INDESIT company

Model type:
IDVA735EU

Commercial code:
F062977

07404-20 Exploded views

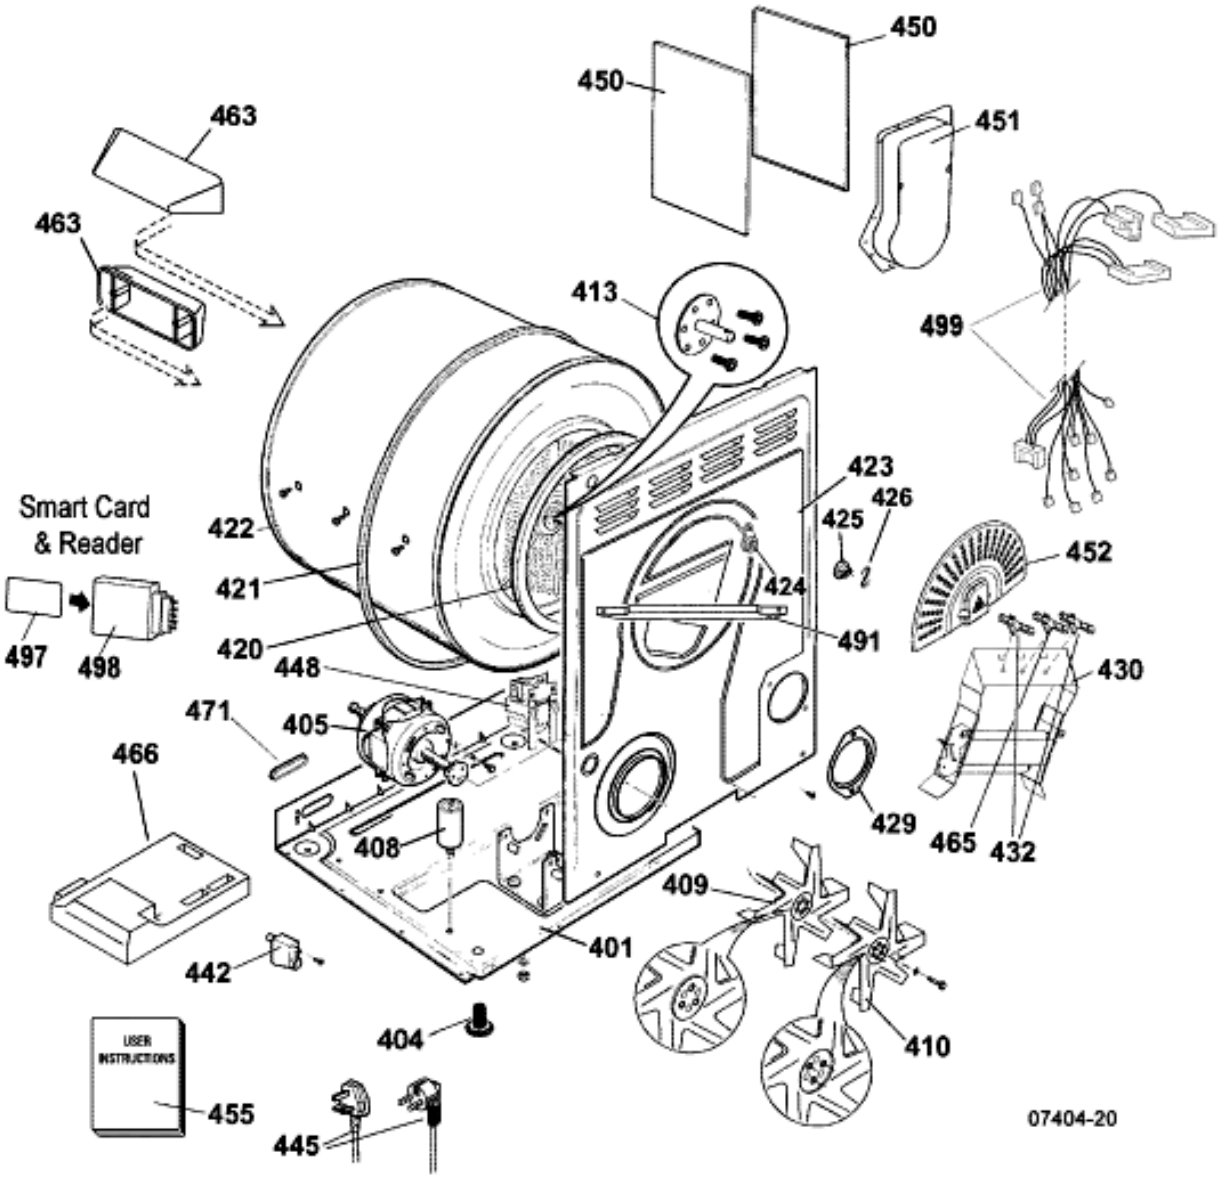
n4408a01: VENTED TUMBLE DRYER HEATERS

From Serial Number 70802.0001, Two different Heater manufacturers were used in production. These DBK and Blaissi Heaters are totally interchangeable if replaced as an assembly.

But the thermostat kits for these Heaters are not interchangeable.

From Serial number 70802.0001, before a Stat. Kit is replaced the heater fitted to the machine must be identified first.
The cover of the Blaissi heater has 2 raised dome shaped pips, there is also a Blaissi Label inside the heater attached to the inside of the heater cover
The Cover of the DBK Heater has 4 raised dome shaped pips.

n4410i00: Introduction of Welling Type 358 Motor

From 17/08/2010 serial No.00817.0001 production started to use a type 358 motor manufactured by Welling, this motor uses a 9µf capacitor.

The Welling 358 motor can be used as an alternative to the previous 358 type motor manufactured by IMEP but a 9µf capacitor must also be fitted.

CAPACITORS
Ana Imep motors had 7.5uf,(6kg models) 8.0uf (7kg models) or 9uf Capacitirs (7.5kg models), fitted in production.
A 9uf capacitor can be used as the service replacement for all machines fitted with a Ana Imep motor.
Welling 358 motors must only be fitted with a 9uf Capacitor.

BOTH 358 MOTORS ARE INTERCHANGEABLE PROVIDING THE CORRECT CAPACITOR IS FITTED

n4410j02: A2 MODULE and HEATER Introduction

A2 MODULE / DELTA HEATER INTRODUCTION
During week commencing 23/11/2009 Serial No.91123.0001 a new A2 power module and heater assembly was introduce in production. This change was gradually introduced starting from the above date with full production due by week commencing 2/01/2010 Serial No.100102.0001. During this period production may vary from the original build to the A2 build depending on availability of A2 components, so to enable easy identification for models produced with the A2 power module and heater assembly, there will be a circular BLUE label (see Attached image) attached to the rear of the machine near the appliance rating plate. The label will be discontinued when full production of A2 module and heater is achieved on 02/01/20010.

n4412c01: VENTED TUMBLE DRYER DRUM LIFTER

From Sept 2011, a curved drum lifter, has been used in production, the new lifter is fully interchangeable with the original straight drum lifter, once stock of the straight drum lifter is exhausted, the curved drum lifter will become the Service Spare, for all production dates".

07489-05 Exploded views

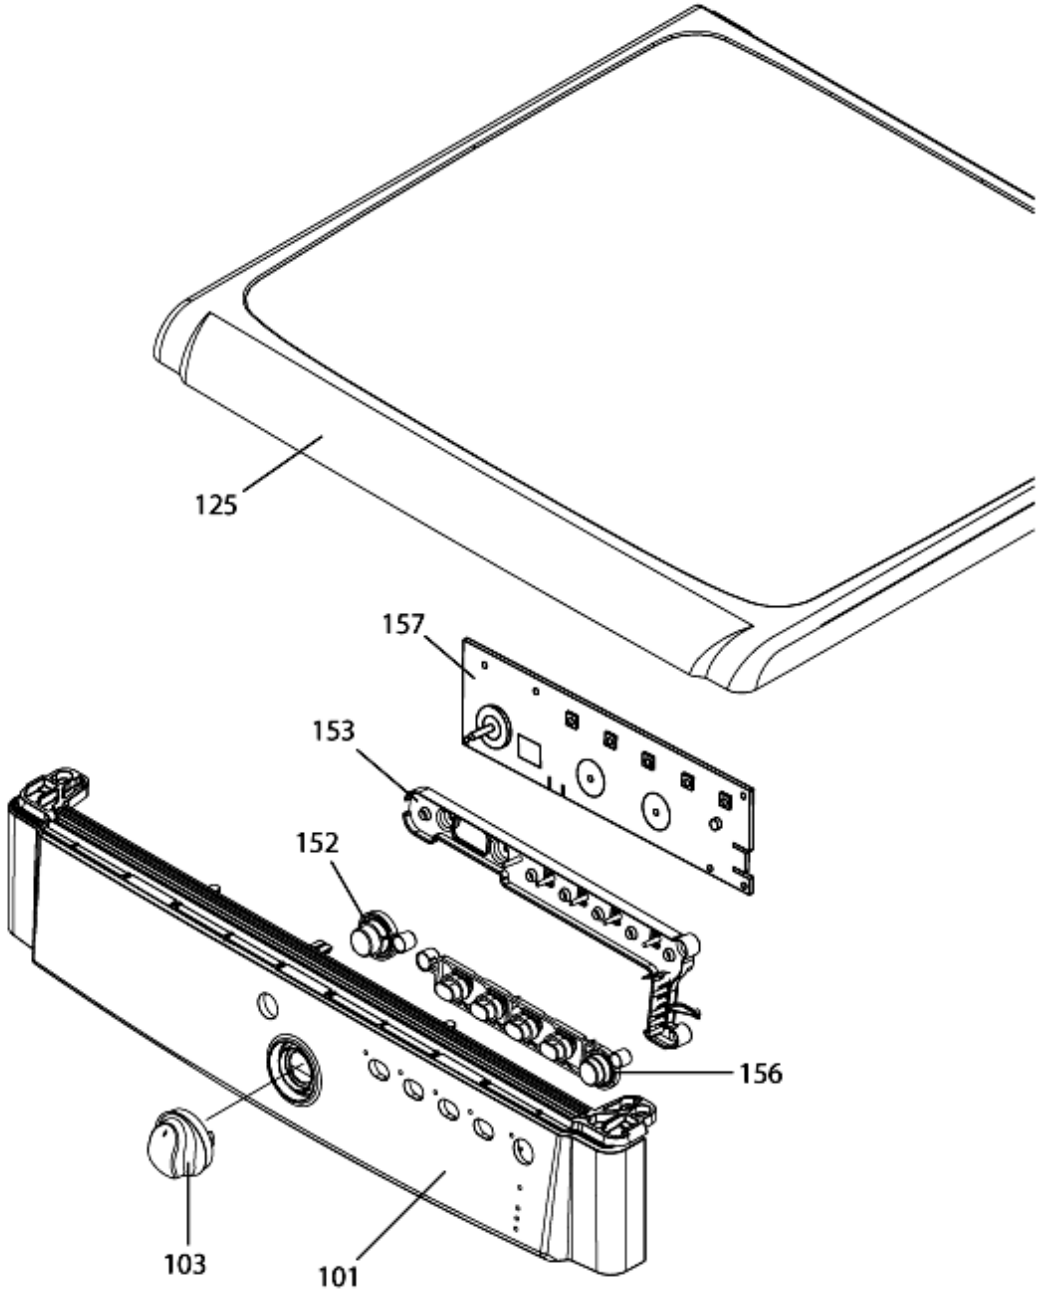
n4409k01: Introduction of Interface Module with Stand–By

From serial number 91102.0001 a new interface module with ‘Stand-By’ was introduced on production and is fitted to all electronic tumble dryers. The "Stand-By" mode is activated after the machine has finished the programme. This module can be used as a direct replacement for the version without Stand-By.

n4410d00: Settings file for ‘Stand-By’

With the introduction of Stand – By from 2/11/09 (091102.0001) Indesit FMD & some Aqualtis models were given a new settings file to rev. 01*. This will have an affect when replacing the electronic interface card and control module.

Service replacement of the electronic interface card will be of the Stand – By version
When replacing a control module or electronic interface card to a model manufactured before 091102.0001 use settings file rev.00.* Stand – By is not affective.

When replacing a control module or electronic interface card to a model manufactured from 091102.0001 uses settings file rev.01.* Stand – By is affective.

07489-15 Exploded views

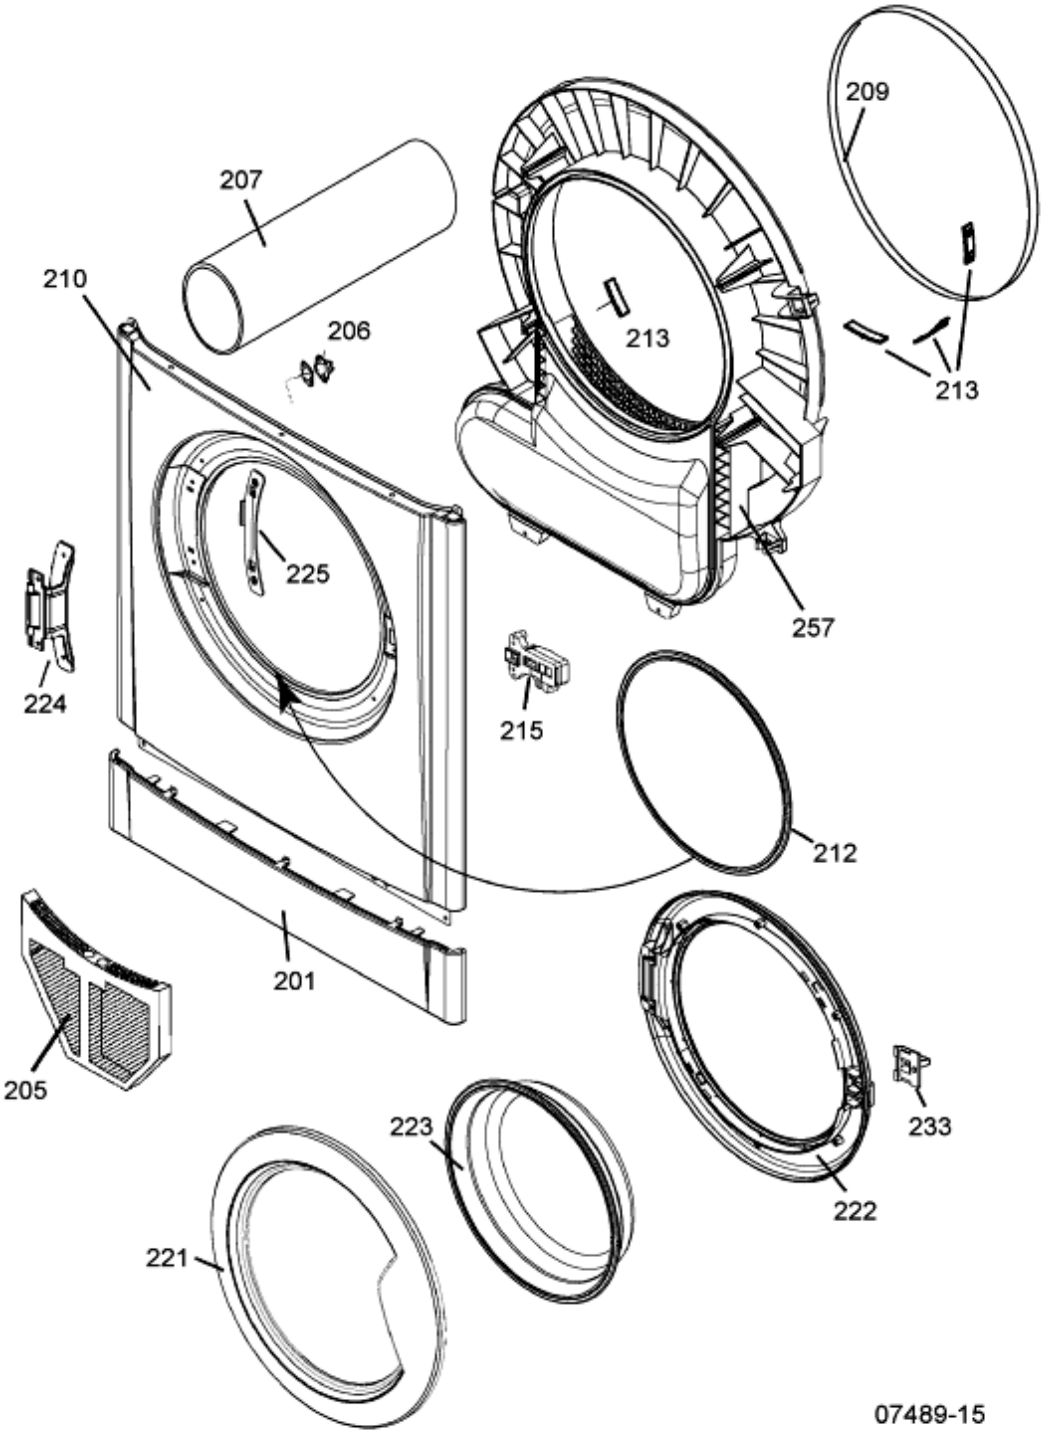
n4411g04: COLOUR CHANGE TO THE FILTER> VENTED DRYERS

FROM JUNE 2011 THE FLUFF FILTER FITTED TO VENTED TUMBLE DRYERS CHANGED IN PRODUCTION FROM GREY TO WHITE.
SELECTED THE CORRECT PART BY DESCRIPTION IN THE PARTS LIST

n4411g06: COLOUR CHANGE TO WHITE FRONT AIR DUCT

FROM JUNE 2011 THE FRONT AIR DUCT FITTED TO VENTED TUMBLE DRYERS CHANGED IN PRODUCTION FROM GREY TO WHITE.
SELECTED THE CORRECT PART BY DESCRIPTION IN THE PARTS LIST

n4409k00: FRONT AIR DUCT & AIR DUCT SEAL

FRONT AIR DUCT SEAL
Both 14mm and 16mm Air Duct Seals have been used in production.
14 mm - used Before Serial No. 50501.0000 (May 2005)and After 00115.0001 (Jan 2010)
16 mm - used Between Serial No.s 50501.0001 (May 2005) and 00115.0000 (Jan 2010) - See note below
If replacing only the Seal - select the CORRECT size from the parts list.
AIR DUCT
White Air Ducts were used in production from 10601.0000 (June 2011), the only difference to the Grey Ducts is the colour change.
WHITE AIR DUCTS ONLY will become the only Service Air Duct Once Stock of the Grey Air Ducts is exhausted
If the original air duct is grey, the air duct kit is required which includes a white filter.
NOTE: ALL SERIAL NUMBERS:
If the AIR DUCT is being replaced you will require a 14mm Seal because the service replacement AIR DUCT is 14mm. See parts List
